Council Development Engineer Comments MOD 2022/0460 (17 November 2022) -

PITTWATER ROAD
CIVIL WORKS

OVERLAND FLOW
CIVIL WORKS
PLAN & DETAILING

Job No :
200303
Drawing No
SW1
per
Lucas Molloy MEA OPEN MER Director

OVERLAND FLOW MANAGEMENT CIVIL WORKS

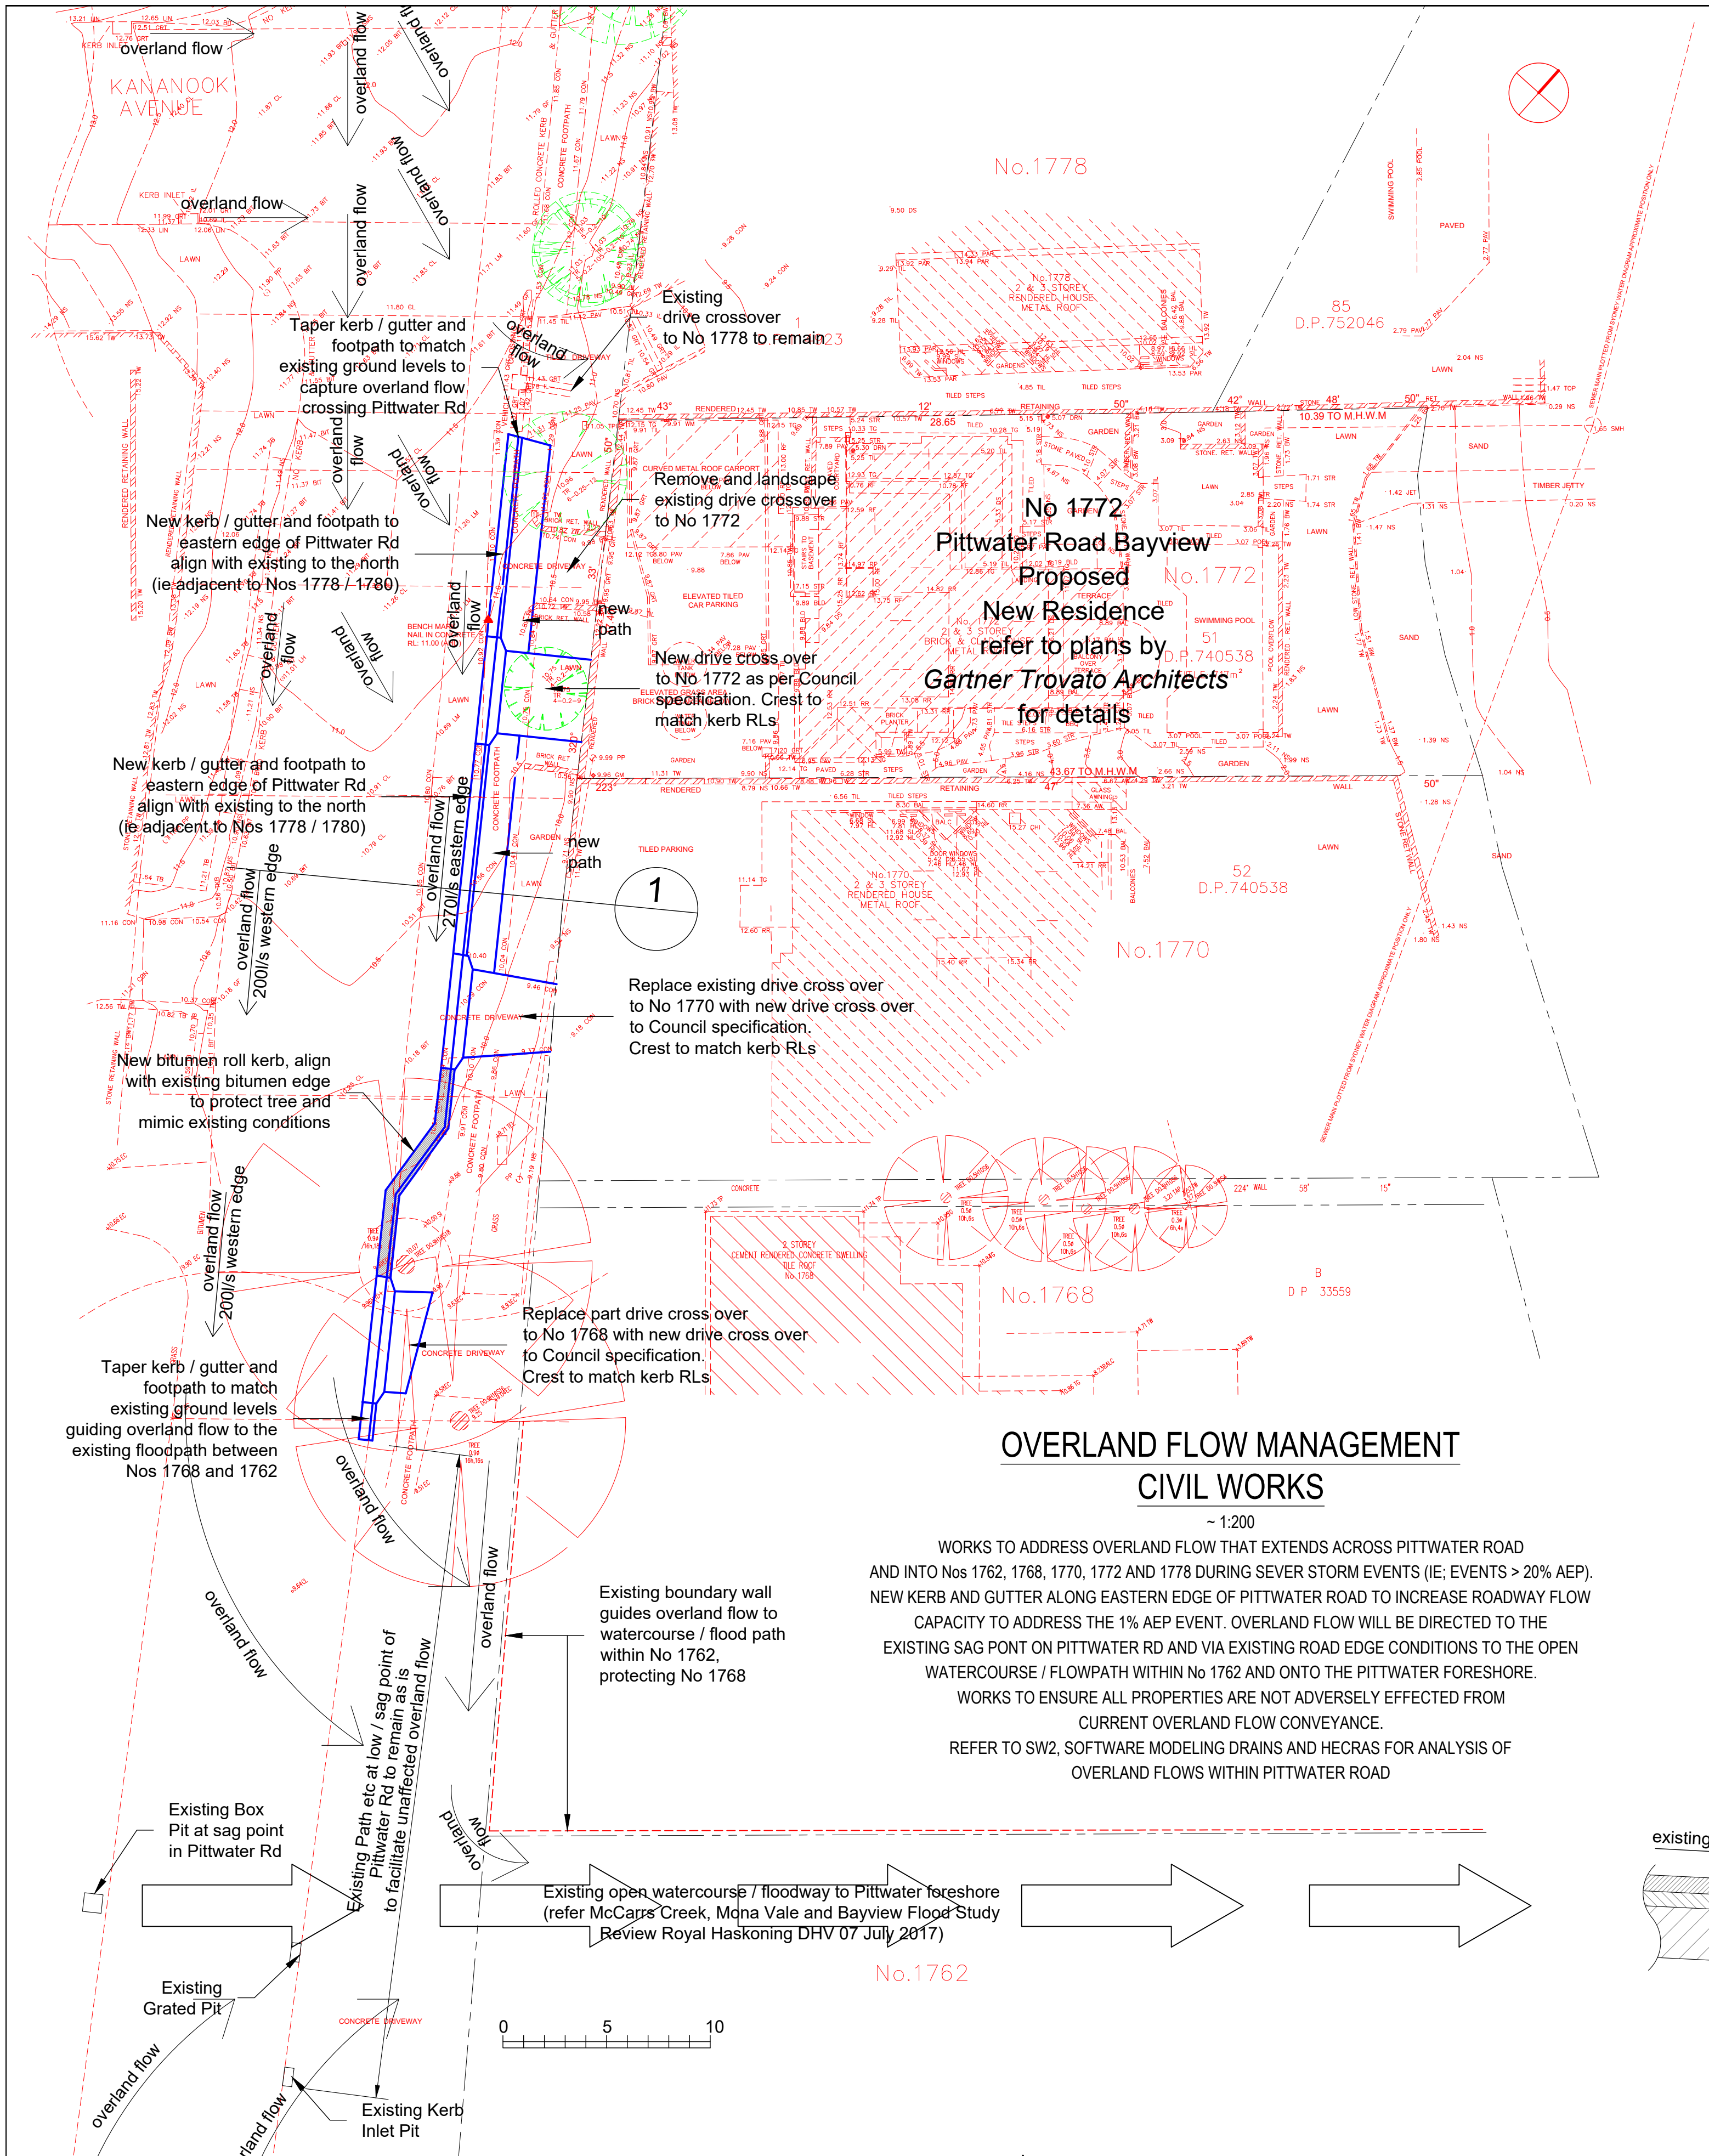
Extending the proposed kerb and gutter to the stormwater pit outside 1762 Pittwater Road, Bayview. The kerb and gutter will need to connect into the existing kerb inlet pit (SPP54339). All downstream properties are low-lying properties, and as such all driveway crests along the extent of kerb works will need to match the Reduced Levels of the new Kerb and Gutter.

Either option will require overland flow modelling to demonstrate that there will be no adverse flooding impacts to adjoining properties. Additionally Hydraulic Modelling for the proposed and existing stormwater system will need to be completed demonstrating that there will be no adverse impacts upstream and downstream.

The works have been designed in a conventional manner typical of standard road works. Flows cresting Pittwater Rd will be conveyed within the kerb and gutter to the existing open watercourse / floodpath and onto the Pittwater foreshore (for detail on floodpath refer McCarrs Creek, Mona Vale and Bayview Flood Study Review Royal Haskoning DHV 07 July 2017).

It is proposed to terminate the kerb and gutter adjacent to / downhill of No 1768s driveway at a point equal with the existing overland flood path off Pittwater Rd. Councils suggested extension "to the stormwater pit outside 1762 Pittwater Road, Bayview" is not practical as this pit is 'uphill' of the catchments low point and will create adverse ponding across Pittwater Rd and a detrimental impact on the flood conveyance.
